## **RESPONSE TO REQUEST FOR INFORMATION - DA2022/01316 & DA2022/01317**

This letter has been prepared in response to the Request for Information (**RFI**) issued by City of Newcastle (**CN**) by email on 4 May 2023 regarding the Development Application to DA2022/01316 & DA2022/01317 relating to Stage 1 and Stage 2 of the development at 711 Hunter Street, Newcastle West.

Figure 1 – Temporary Steel Crash deck to protects resident vehicle entry during podium construction

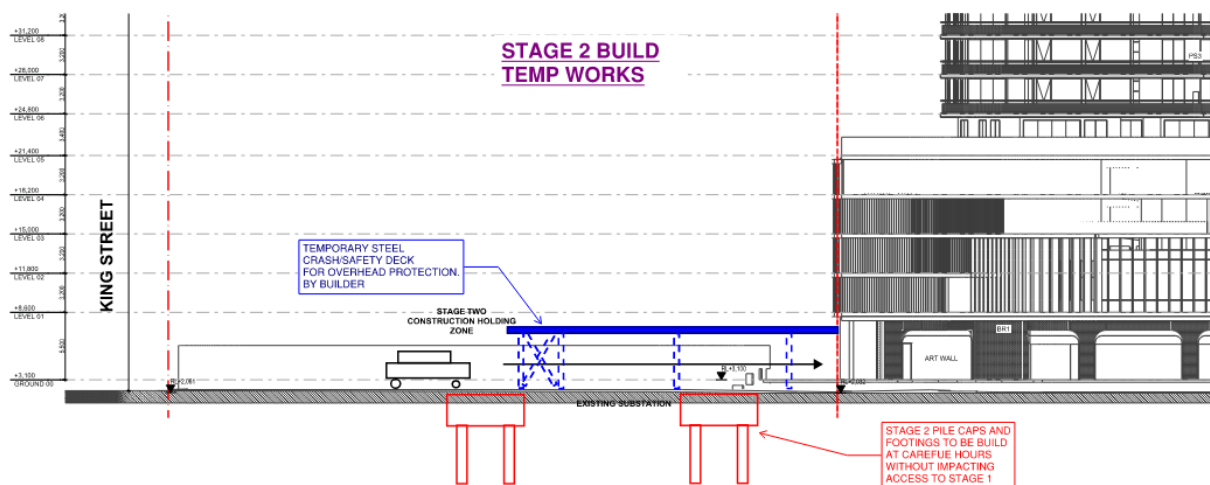
***B. In the event the lower podium is constructed across two stages, as proposed, a detailed analysis being provided outlining the proposed strategy for construction of Stage 2. Further details are to be provided, which address the development will continue the operation of the driveway to Stage 1 whilst also maintaining public (resident) safety and minimising on-street congestion. This is to be presented in a comprehensive staged construction management plan.***

- To ensure safety for the residents, commercial and visitors when entering and exiting the site during the Stage 2 construction, installation of temporary steel crash/safety deck is proposed, refer to **Figure 1**.

Figure 5 – Proposed amendment to northern lobby entrance

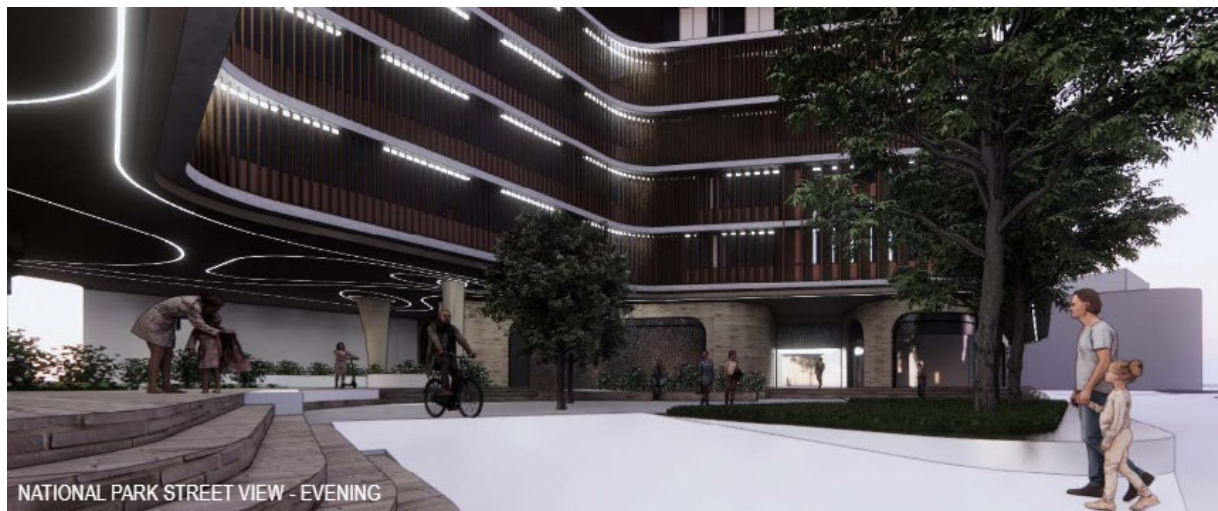
*In this regard, the amended plans must incorporate the recommendations of any specialist report supporting the application. For example, the submitted CPTED report makes numerous recommendations regarding the layout and operation of the proposal which have not been incorporated into the architectural plans (e.g., lobbies to each tower and separation of commercial and residential elements (including parking and storage cages).*

- The ground floor lobby entry for the northern tower is proposed to be relocated closer to the central area, as well as an additional window to its adjacent retail tenancy to improve its visibility from the street. Indicative street views are provided by Plus to illustrate how the combination of the ground plane, residential, retail frontages, as well as landscaping and lighting work together to create a highly activated ground plane. The CPTED recommendations have been clearly articulated within the supporting architectural drawings. The Architectural Plans have provided an indicative ground plane view as pictured in Figure 5 . It displays how the residential and retail frontages as well as landscaping will work together to activate the ground plane for improved safety.

Figure 9 - Substation location

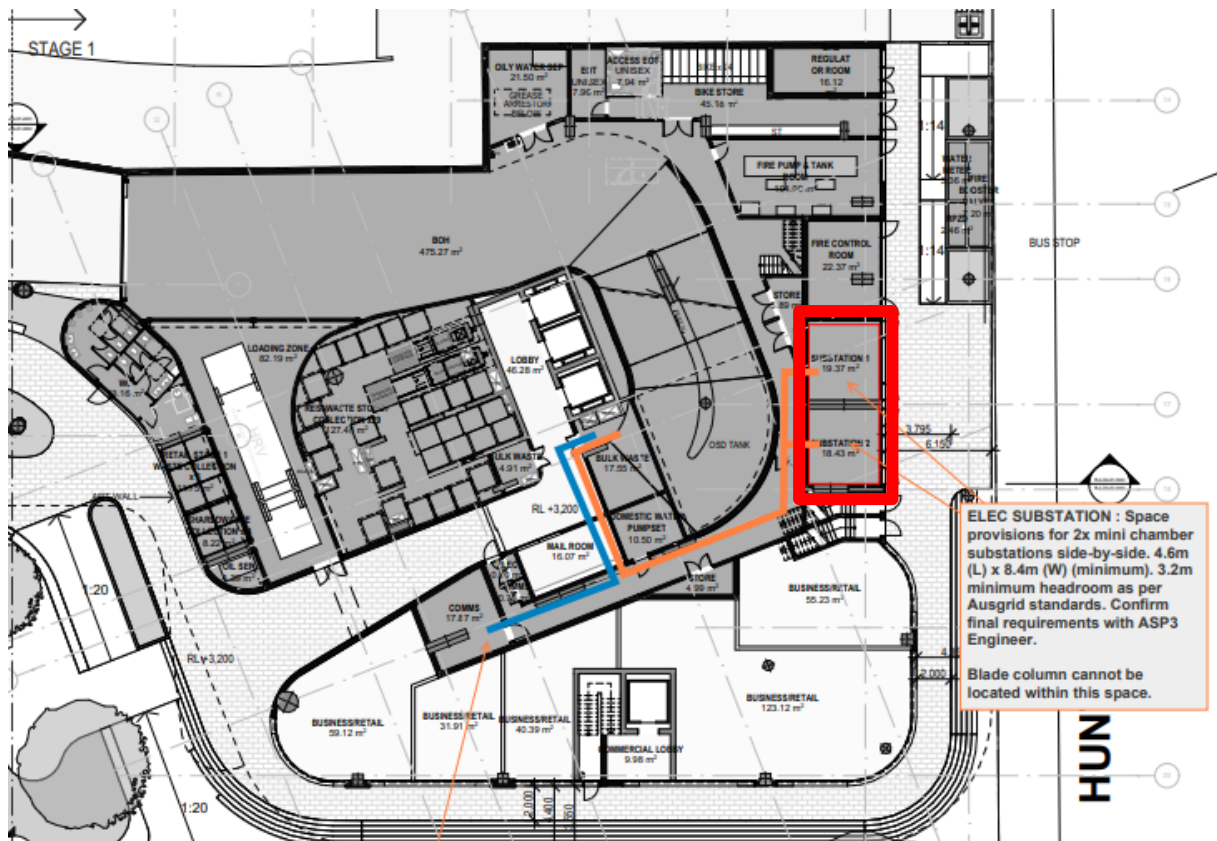
*The location of on-site substations is to be confirmed and detailed on the submitted plans. It is noted that an existing substation is located within the proposed Stage 2 area. Further clarification is required concerning upgrades of the public utilities and proposed location for future services.*

The existing substation will not be retained, and a new substation is proposed facing Hunter Street. This will involve application for a new load connection which will have to be submitted with a maximum demand calculation. Significant testing went into alternate options for the required substations. Ausgrid require direct street access and driveways are not acceptable for compliance, making the driveway and King Street inappropriate locations for the substations.

The substation location was considered resolved at DIP Session No. 2 by the Panel and the location is shown in **Figure 9**, outlined in red.

Figure 12 – Views from Aero Apartments to Merewether

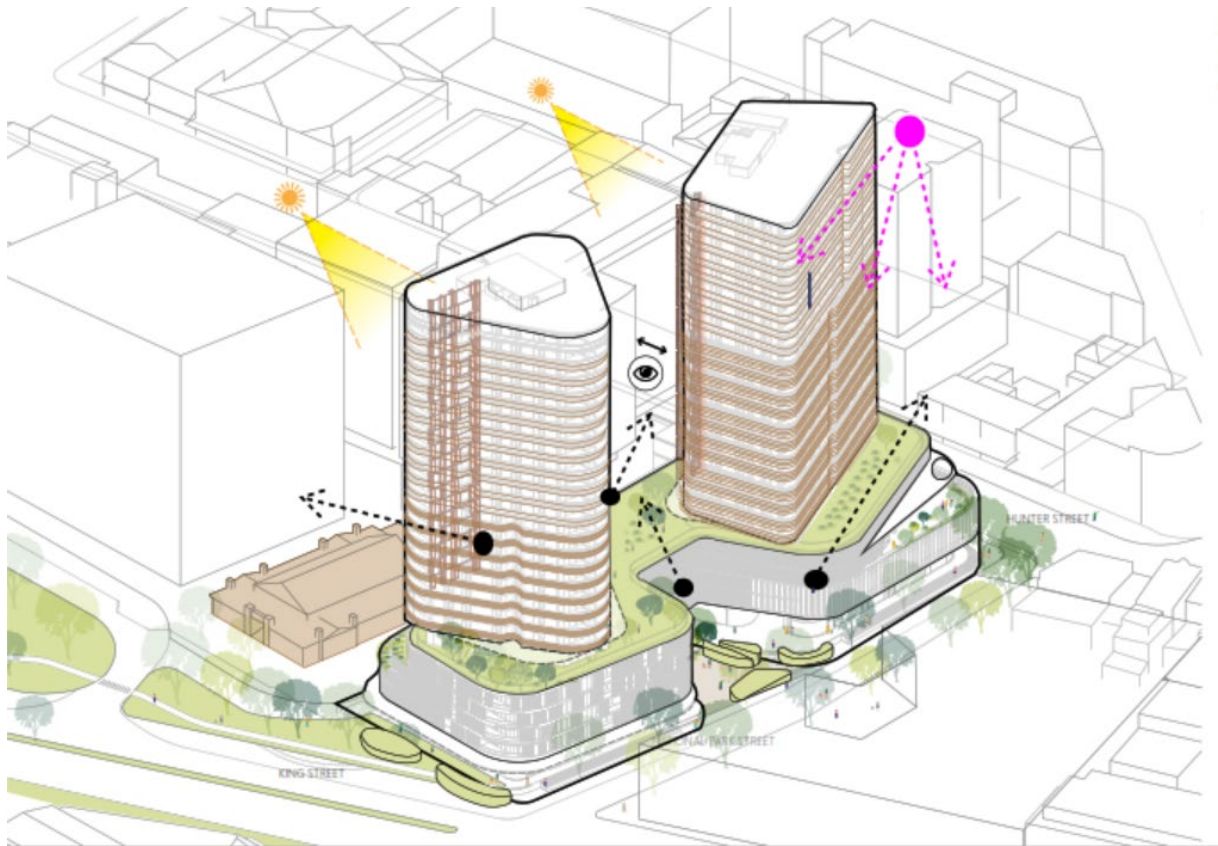
- *The application has not been accompanied by a View Impact Study or assessment.*
- *Due to the scale of the building, several view corridors will likely be impacted. One of the objectives of the B3 zone is to: “provide for the retention and creation of view corridors.” The application has not adequately addressed the issues of view sharing as provided for Tenacity Consulting v Warringah Council [2004] NSWLEC 140. This Land and Environment Court case provides a four-step assessment process to be used when making planning decisions with respect to view sharing. It is contended that the proposal in its current form would not adequately address the concept of “view sharing”.*

The views enjoyed by Aero Apartments to Merewether Beach were taken into consideration during the design development phase and contributed to the determining the orientation and angling of the northern tower, refer to **Figure 12**.

The proposed development results in a better outcome than a compliant tower form when considering views to Merewether from the Aero Apartment. The proposal responds to the unique site-specific provisions, specifically the commercial building sets the urban form which the northern tower responds to. If proposal had to provide 24 metres between the northern tower and adjacent commercial development the tower would be pushed toward National Park Street and Hunter Street and would overwhelm the public domain and impact views from the Aero Apartments.

Figure 13 – Carpark headlight spill

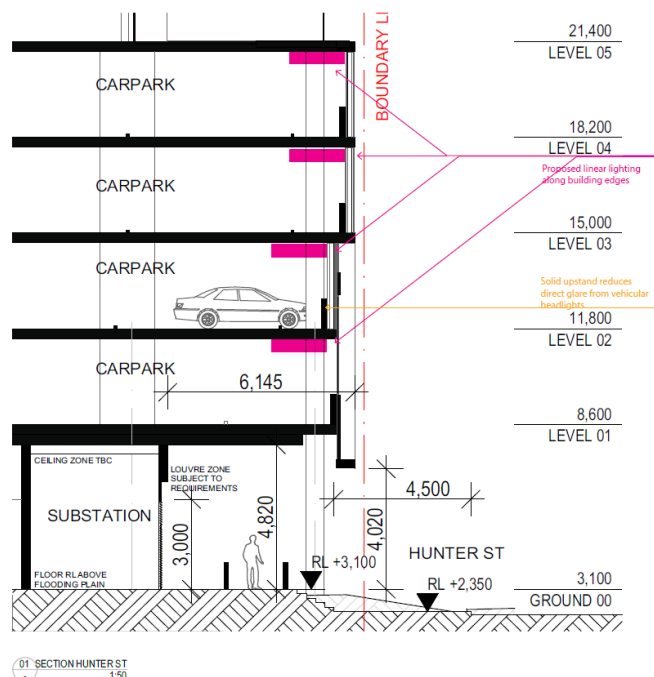
- *The proposed development should not add to and exacerbate the issues created by the development of the adjacent office tower and the impact on existing residents due to the unsuitable cladding/design of the above-ground car park and light trespass it has created for residents.*

In response to the headlight, a spill solid upstand are the car park edges has been implemented to mitigate direct glare from vehicles as they manoeuvre through the car park, refer to **Figure 13**. This will provide filtering of artificial light that will appear in an interesting and less impactful way.
